## Open Top Technical Bulletin OT TB 001, July 2015 (Revised)

**Title: Open Top Container Roof Bows – Updated Criteria**

**Component: Roof Bows**

Improperly fitted roof bow end

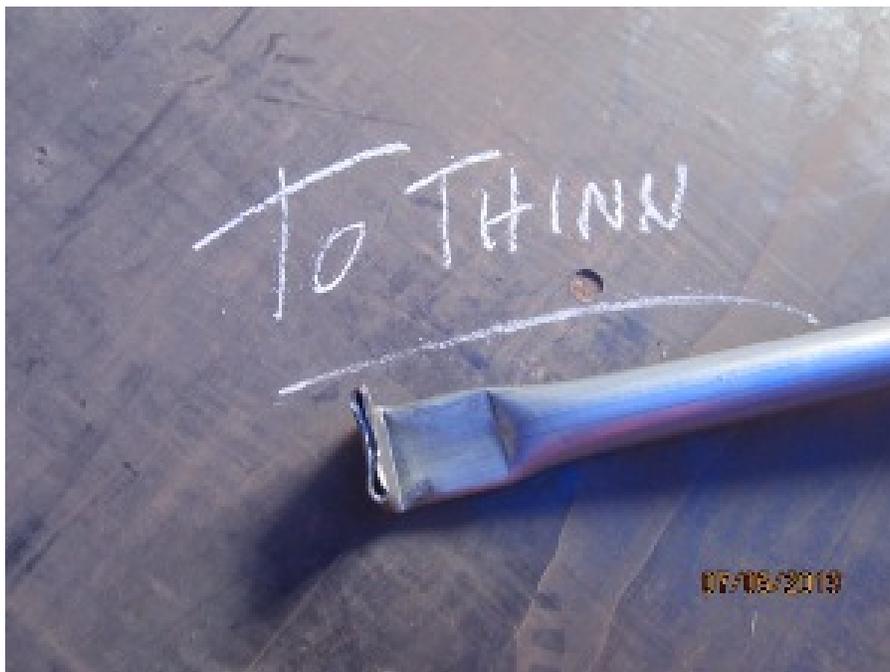
Improper Section  
Will cause tarp damage

Improper section

No camber

Improperly fitted roof bow

Improper bows  
Wrong material (not galvanized)  
No camber

- Improper material (bows that are not galvanized)  
NOTE: The bow should be hot dipped galvanized
- Bows that are too thin (improper diameter)  
NOTE: The bow dimensions should be 34mm (1 3/8inch) diameter with a thickness of 3mm (1/8 inch)
- Bows that are sectioned improperly (refer to owner)
- Bows that are improperly fitted (mated to holders at top rail)
- Bows should have a minimum camber of 30mm (1 1/8 inch)
